City of Portland, Maine - Building or Use Permit Application

Permit No: 02-0422	Issue Date: MAY - 3 2002	CBL: 141 F040001
-----------------------	-----------------------------	---------------------

Past Use: single family	Proposed Use: demo existing garage, addition of 16' x 12' screen porch and 20' x 28' second floor addition	Permit Fee: \$492.00	Cost of Work: \$67,000.00	CEO District: 2
Proposed Project Description: DEMO GARAGE addition of 16' x 12' screen porch & second story		FIRE DEPT: <input type="checkbox"/> Approved <input checked="" type="checkbox"/> Denied N/A	INSPECTION: Use Group: R-3 Type: SB BOCA 1999

CHECK-LIST AGAINST ZONING ORDINANCE

1ST FLOOR
Zander Residence
47 Gledhill Rd.
Portland, ME 04103

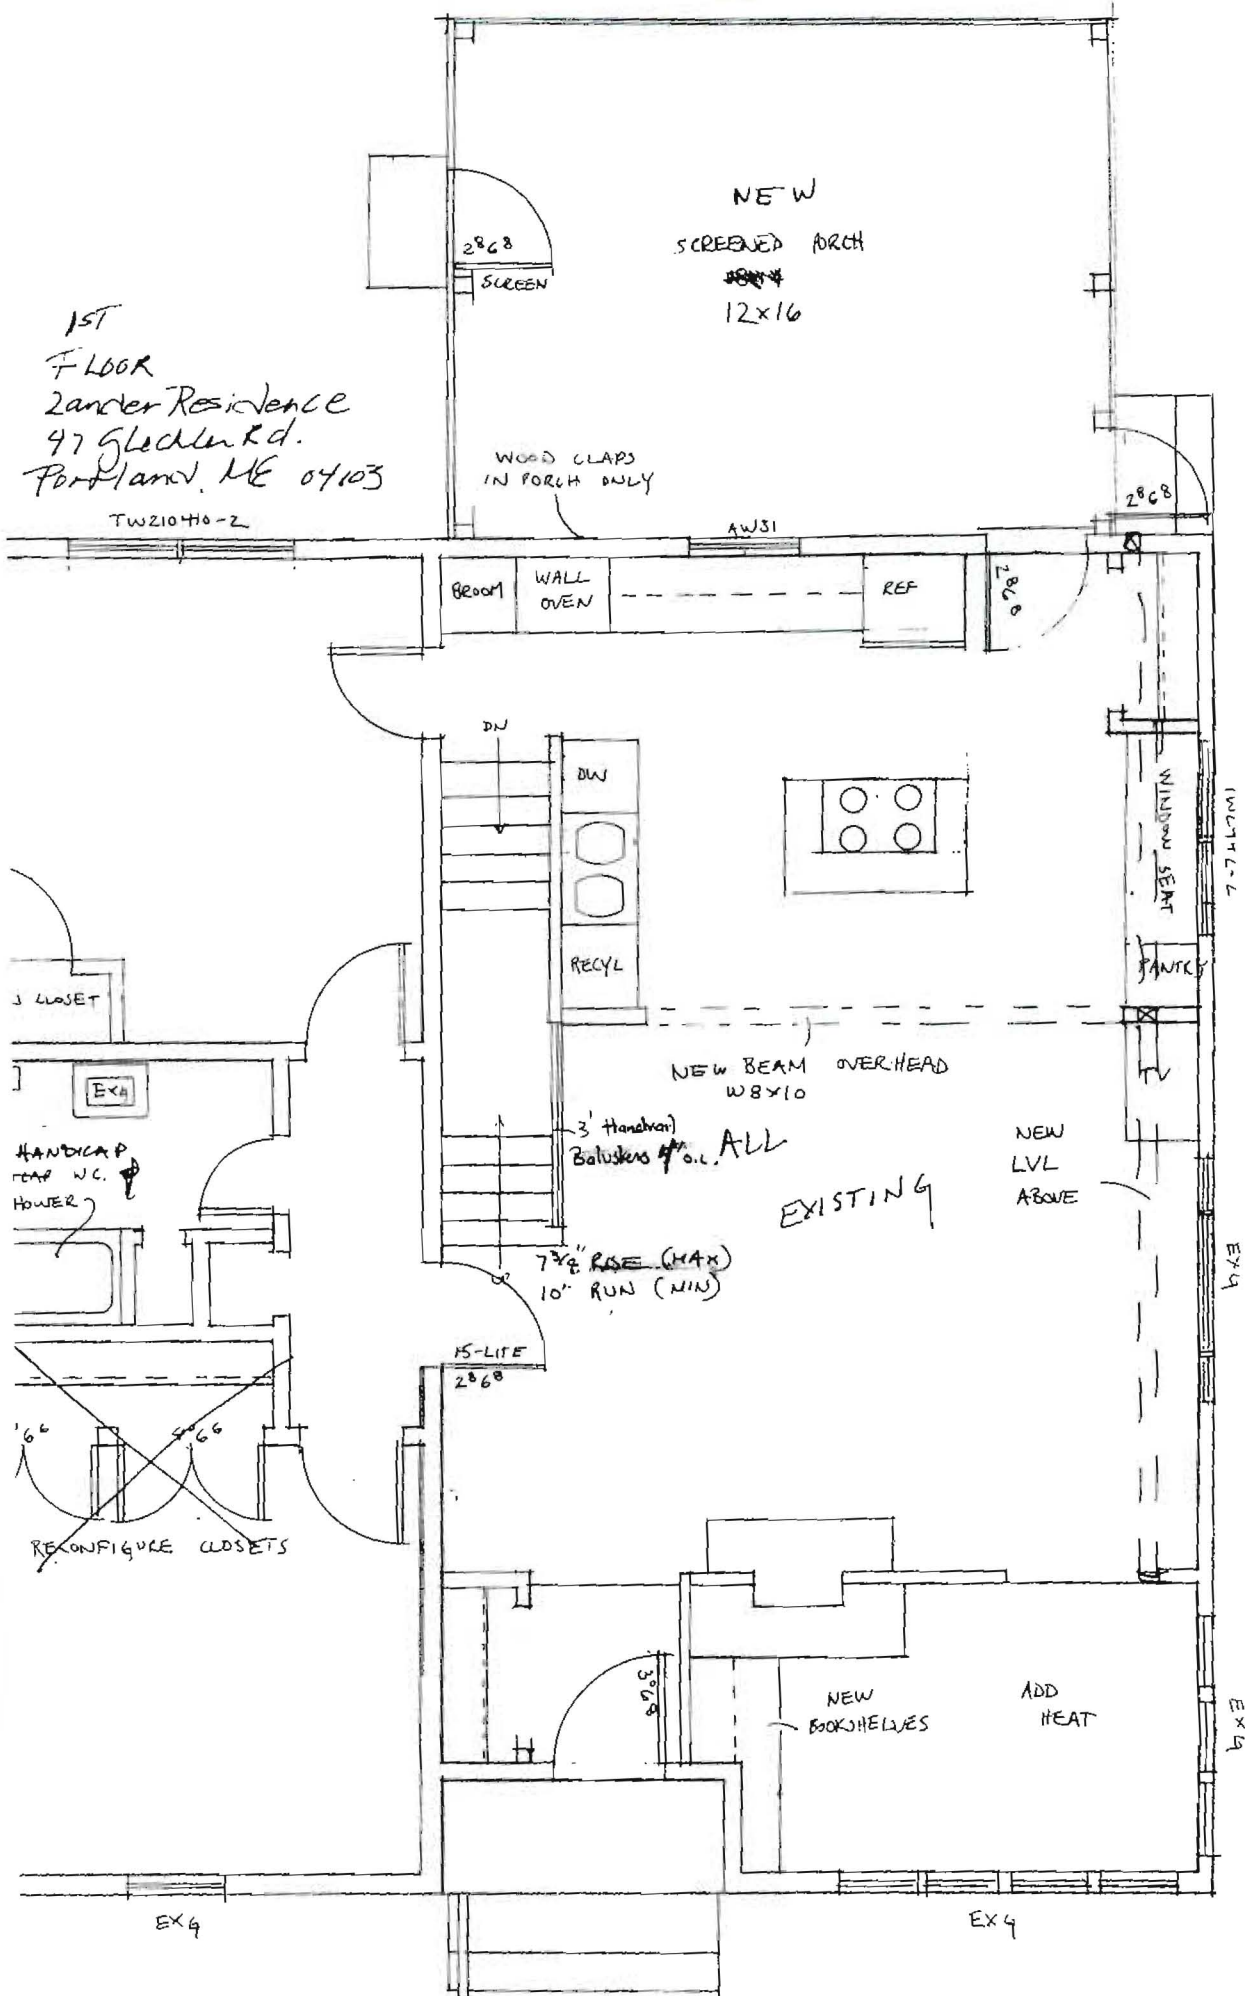
ADD HAND RAIL
 FIRST FLOOR

ADD
HEAT

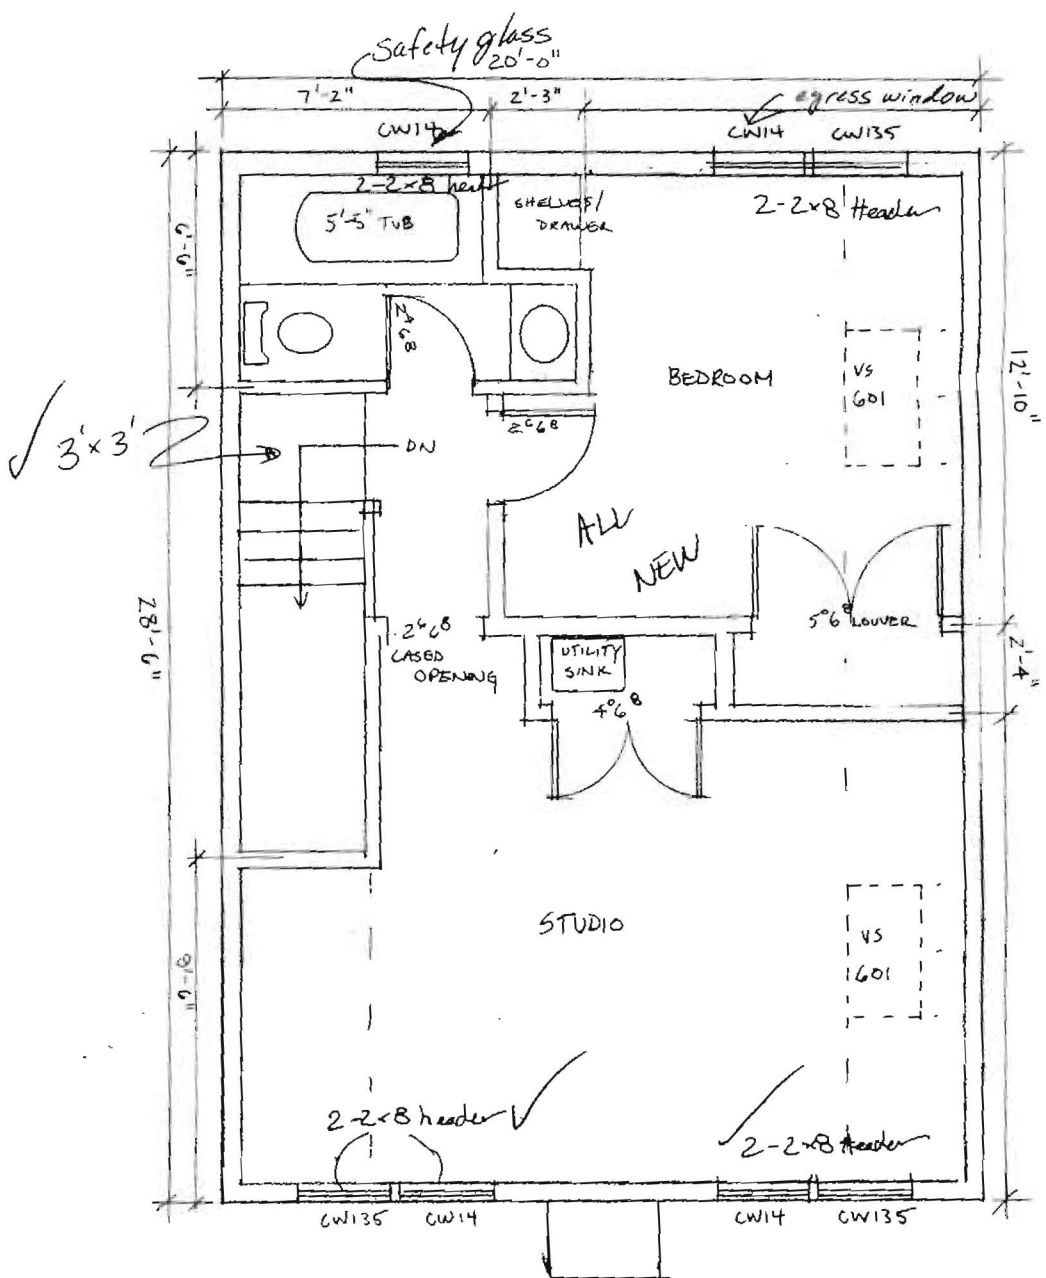
Smokes installed
